Frankfort Castle

Dundrum, Dublin 14

Statement of Response
June 2021

RESPONSE TO ISSUES RAISED BY ABP

Context Elevation 05

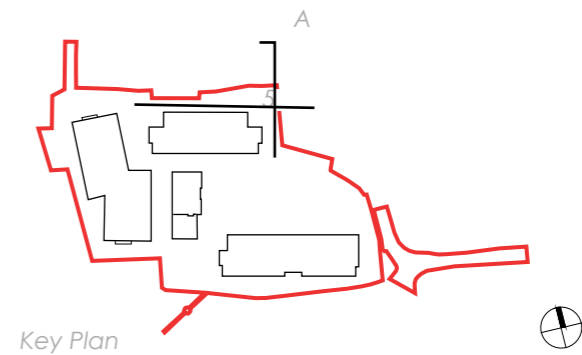
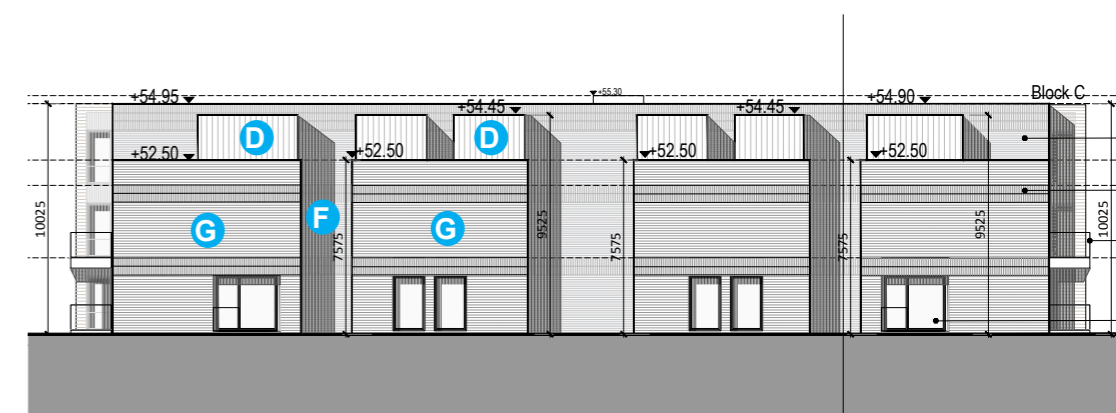
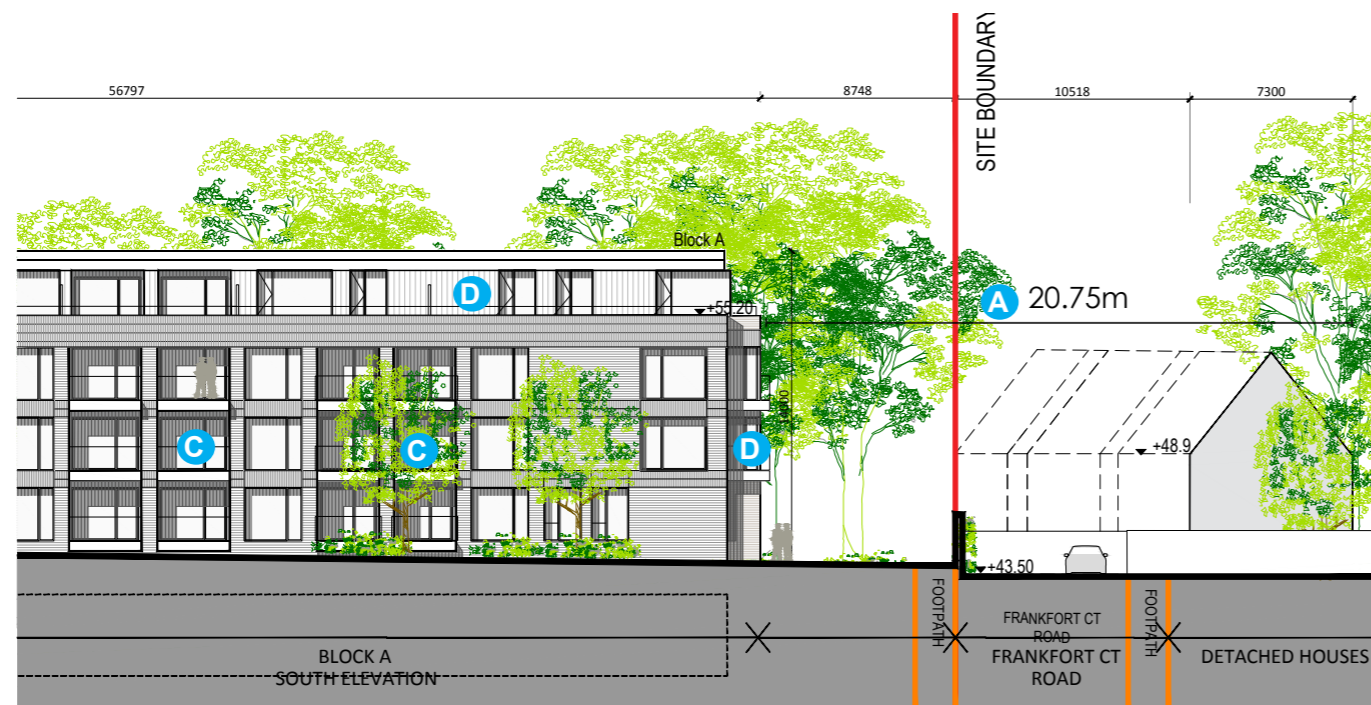
Mitigation/changes that are included to deal with potential overlooking of Block C east gable elevation, through semidetached House no. 107-109 Highfield Park

- A** • The separation distances to the houses are circa 31m
- B1** • The retained trees stand between the proposed scheme and the existing houses create a natural privacy screen .
- C** • Inset balcony to increase the distance to the back gardens and reduce the vision angle.
- D** • Recessed terrace / stepped old profile to increase the separation distance at the top floors.
- F** • The directional windows are on level 1&2 at the north side of Block C.
- G** • The north elevation facade is blank at levels 1 & 2 to provide privacy to the adjacent neighborhood properties.

Context Elevation 07

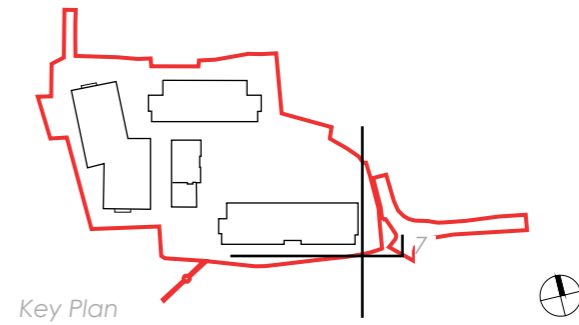
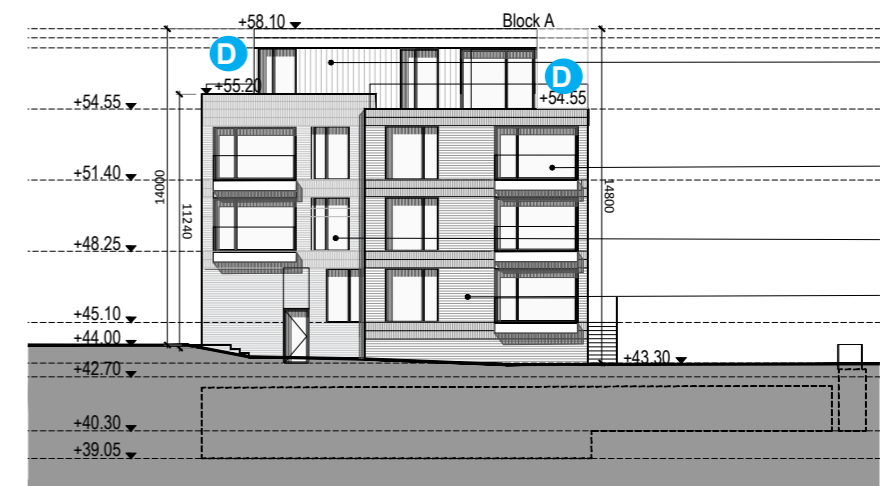
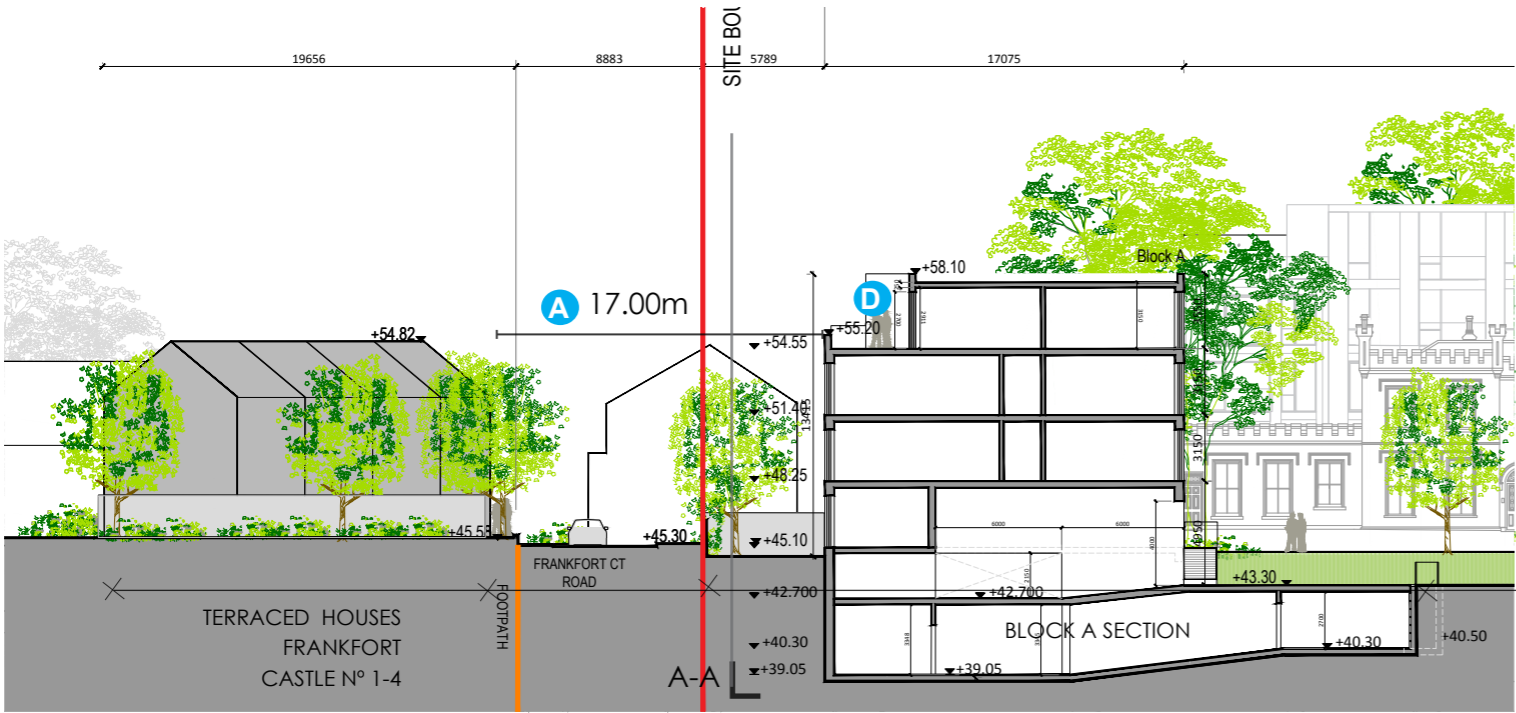
Mitigation/changes that are included to deal with potential overlooking of Block A southward elevation and section through Frankfort Castle Road.

- A** • The separation distances to the houses are circa 20 m
- C** • Inset balcony to increase the distance to the back gardens and reduce the vision angle.
- D** • Recessed terrace / steeped old profile to increase the separation distance at the top floors.

Context Elevation 08

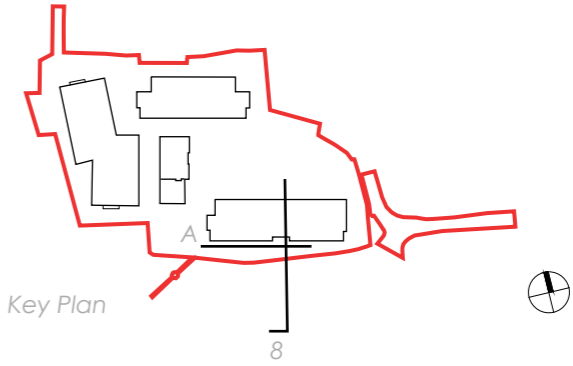
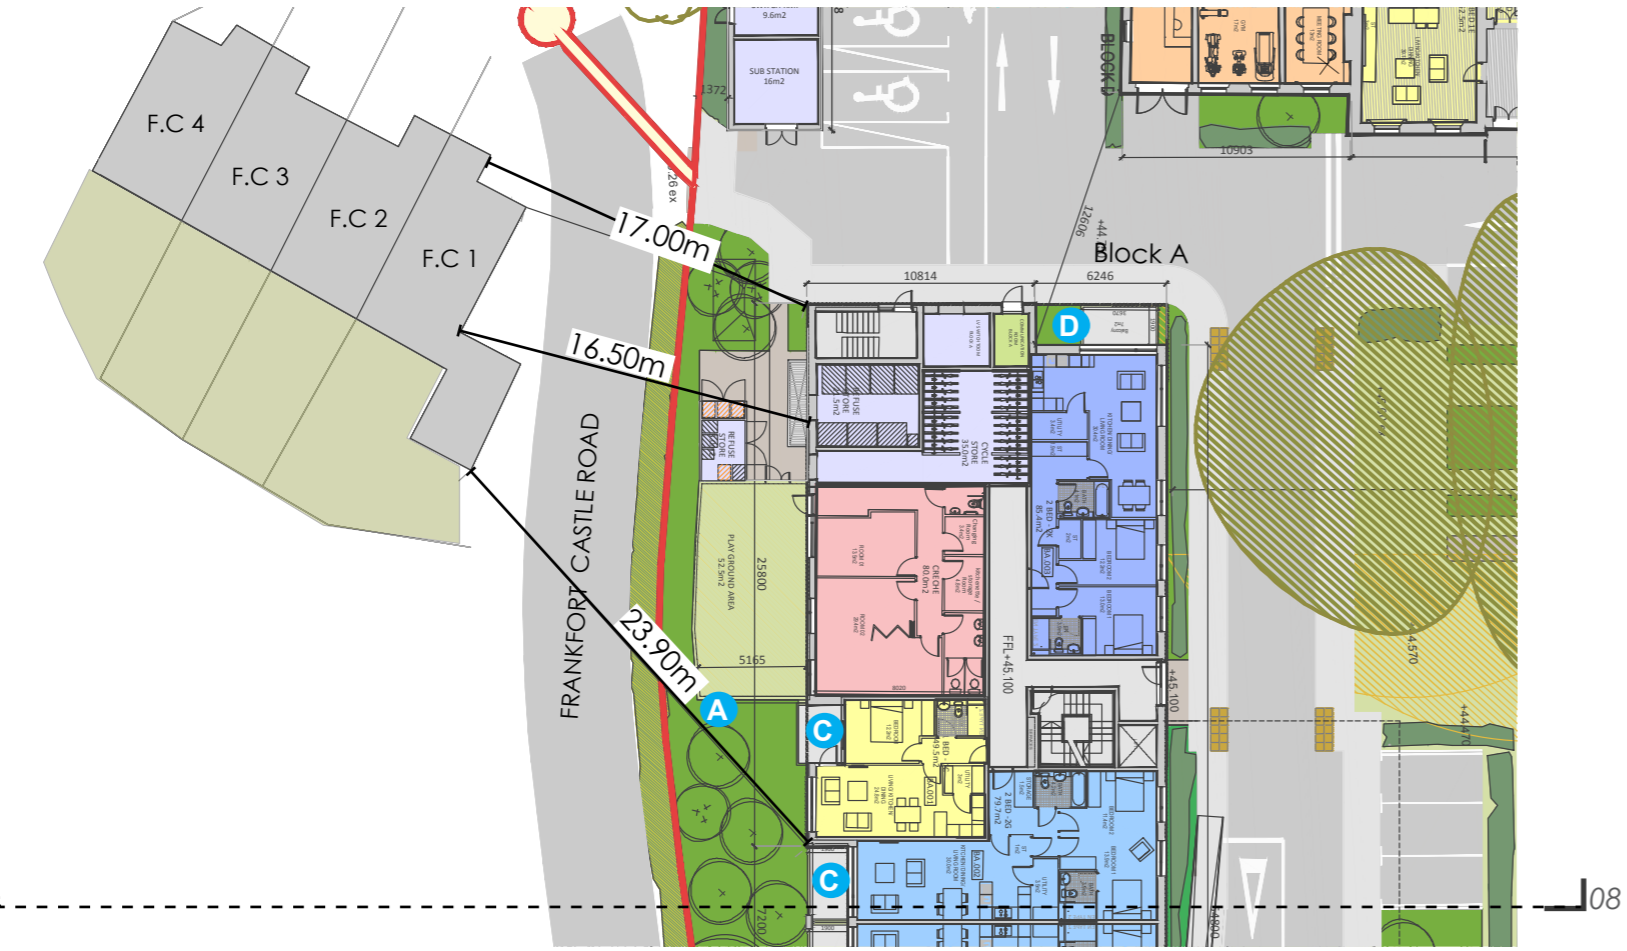
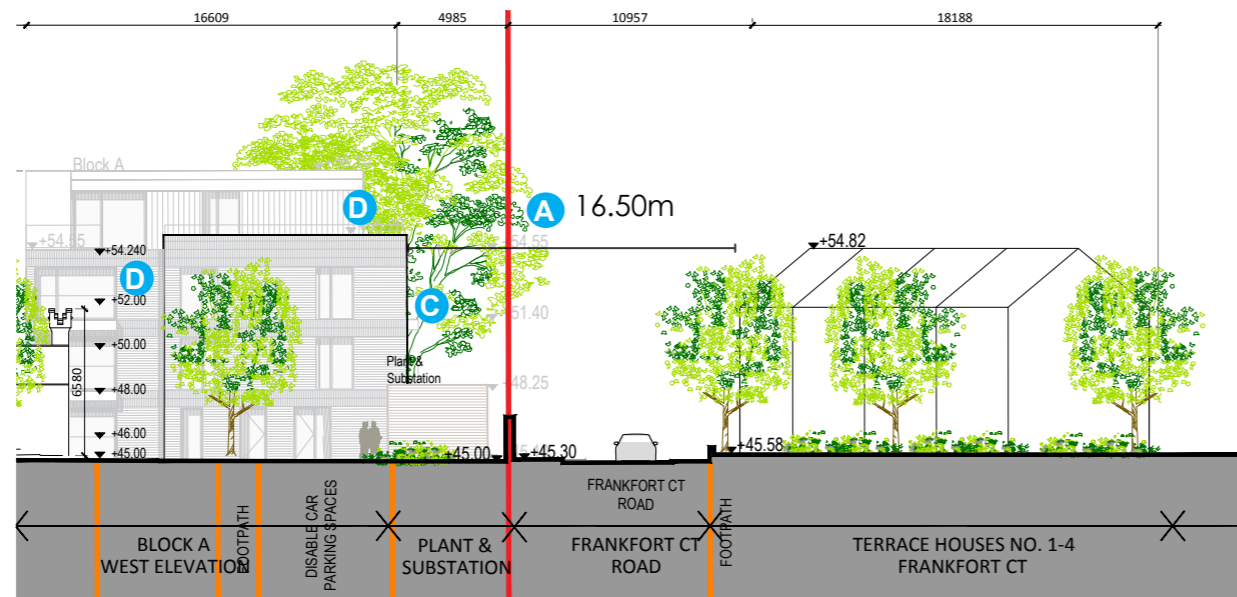
Mitigation/changes that are included to deal with potential overlooking of Block A westward cross section

- A** • The separation distances to the houses are circa 17 m
- C** • Inset balcony to increase the distance to the back gardens and reduce the vision angle.
- D** • Recessed terrace / steeped old profile to increase the separation distance at the top floors.

Context Elevation 09

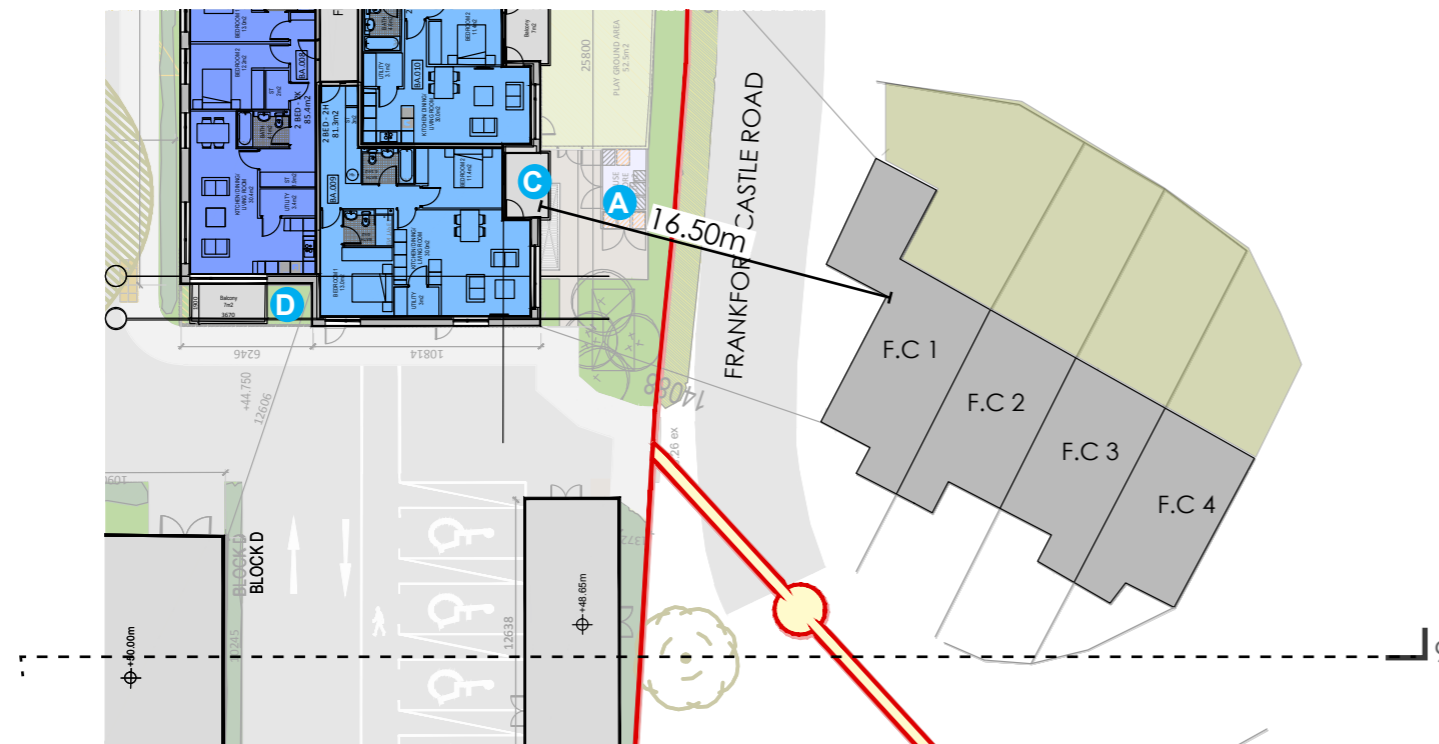
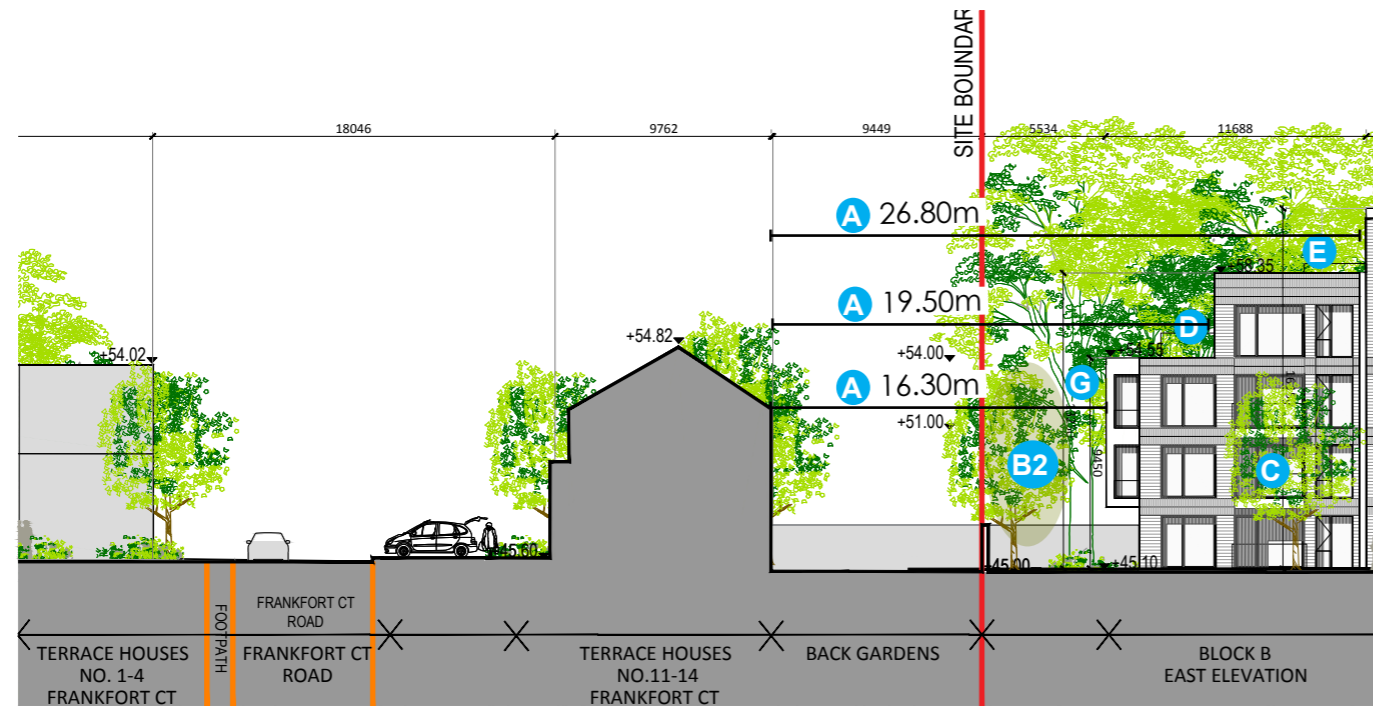
Mitigation/changes that are included to deal with potential overlooking of Block A west gable elevation towards Frankfort Castle road terraced Houses no.1-4

- A** • The separation distances to the houses are circa 20 m
- C** • Inset balcony to increase the distance to the back gardens and reduce the vision angle.
- D** • Recessed terrace / steeped old profile to increase the separation distance at the top floors.

Context Elevation 10

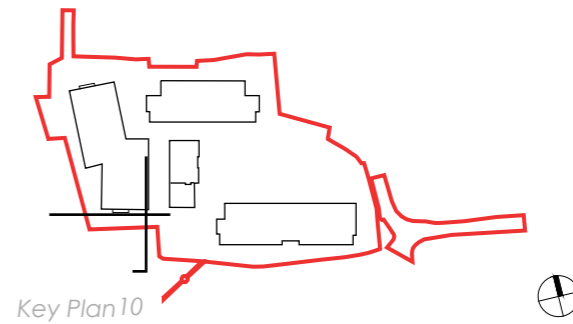
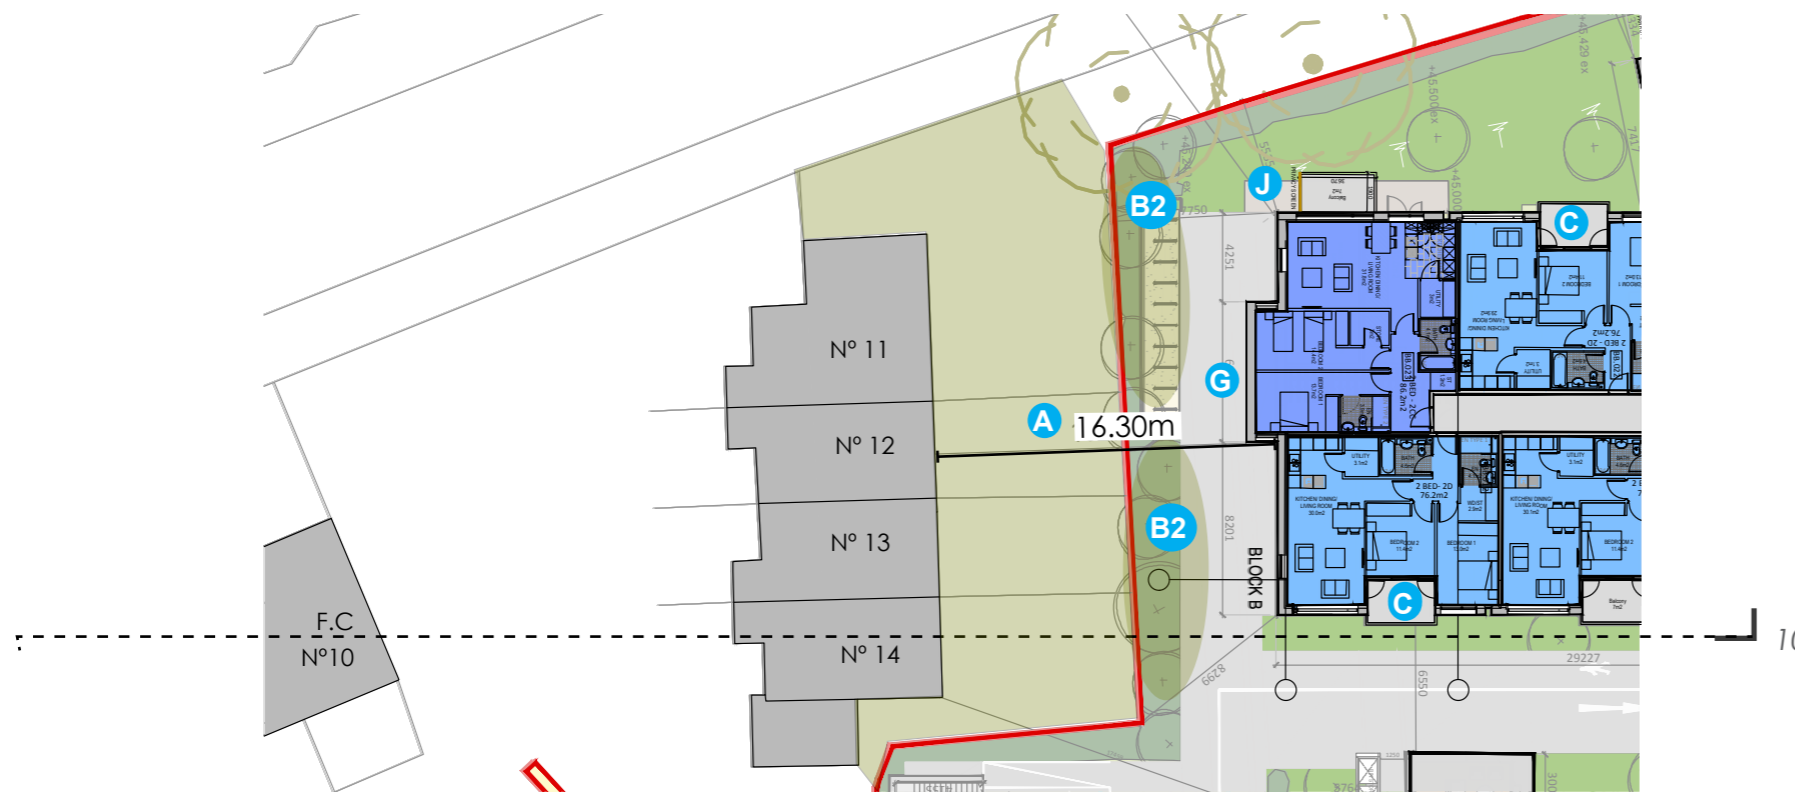
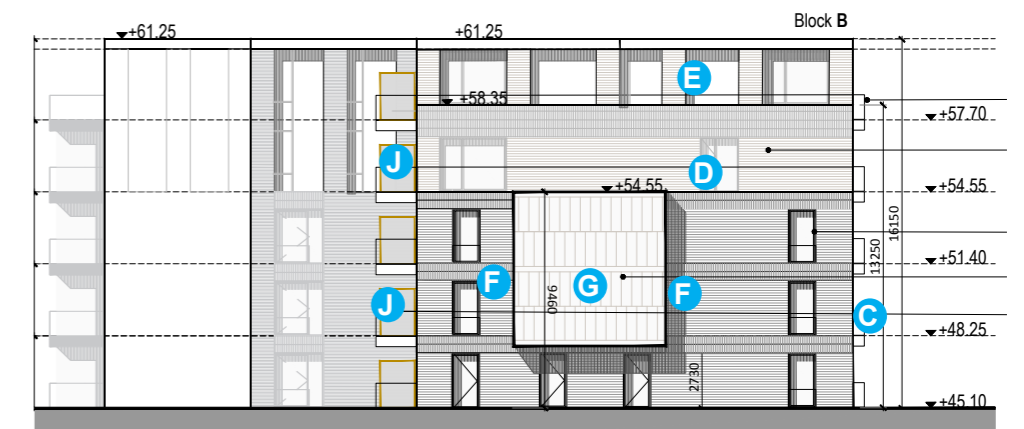
Mitigation/changes that are included to deal with potential overlooking of Block B South-Eastward elevation towards terraced Houses no.11-14 at Frankfort Castle Road

- A** • The separation distances to the houses are circa 23-24m
- C** • Inset balcony to increase the distance to the back gardens and reduce the vision angle.
- J** • There are proposed privacy screens to avoid the overlooking to the adjacent properties on the projected corner balconies
- D** • Recessed terrace / steeped old profile to increase the separation distance at the top floors.
- E** • The roof areas are not accessible from the inner apartment units to avoid the overlooking.
- G** • The most exposed elevation area on the block B gable elevation is blanked to provide privacy to the neighbourhood properties.
- B2** • New trees proposed and planted within Frankfort Castle scheme that stand between the proposed scheme and the existing houses create a natural privacy screen .
